Service Bulletin

Bulletin No.: PIC6645

Subject: Amplifier Inoperative Due to Water Intrusion

Brand:	Model:	Model Year:		VIN:		Engine:	Transmission:
		from	to	from	to		
Cadillac	OPTIQ	2025 - 2026		SOP	October 2025	All	All

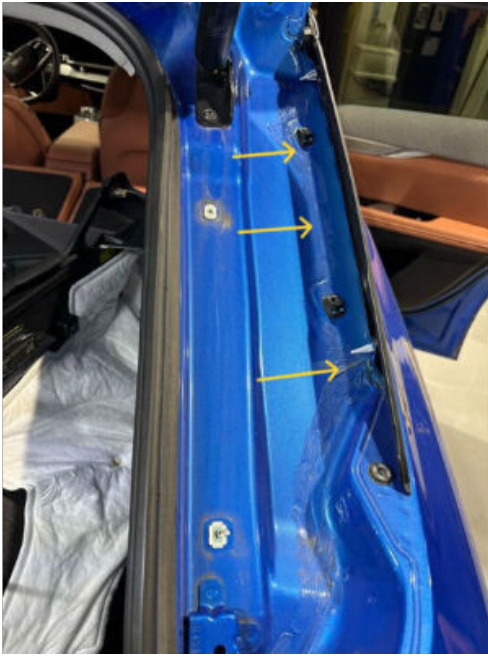
Involved Region or Country	North America
Condition	Customers may comment that they have no audio that is present regardless of key cycle.
Cause	Water intrusion from lateral panel body behind right-hand auxiliary stop lamp.

Technicians are to verify the leak path is present and re-seal the seal area, see images below.

Remove trim to access body seam.

Inspect for holes or voids in the seam sealer, and bumps that do not allow the rubber locators for the taillight to sit flat.
